Gairloch Wastewater Treatment Works

Technical Review

Project: Gairloch Mission – Technical Support

Document Title: Wastewater Treatment Review

Figure 2-1: Treatment works inlet flow 2017

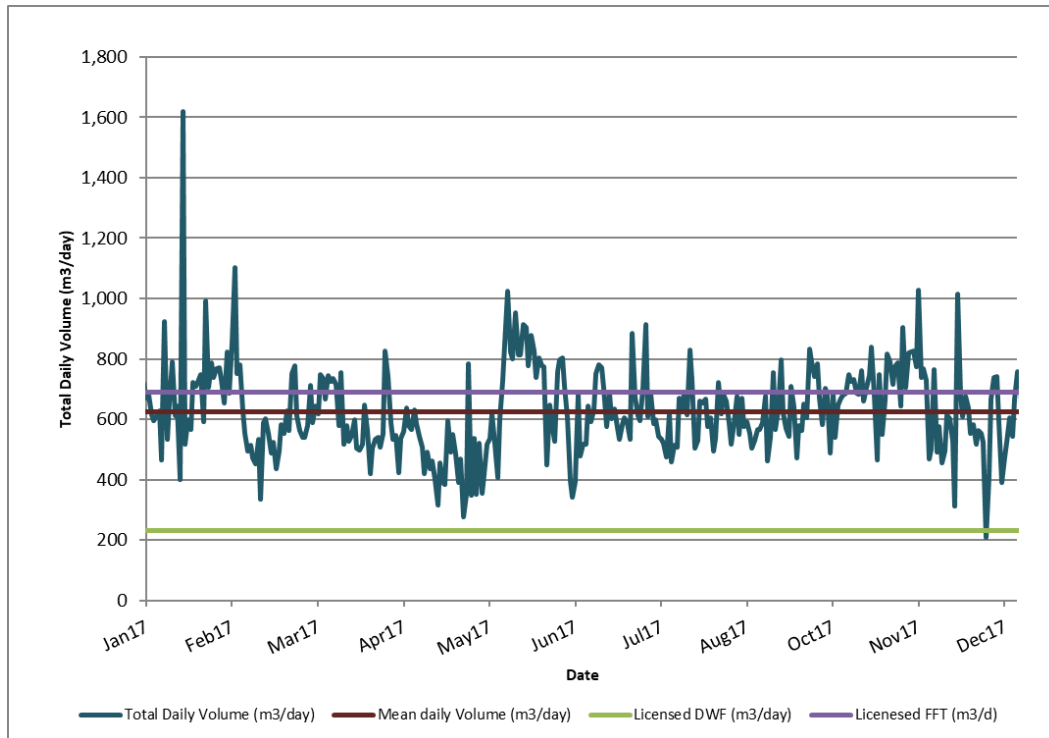
It also appears from Figure 2-1 that the WwTW does, at times, treat significantly more flow than the current license requirement. This may indicate pump control issues or inaccuracies in the inlet flow measurement.

Reviewing the veracity of the flow information will confirm any impacts upon licencing, the current design or the proposed design.
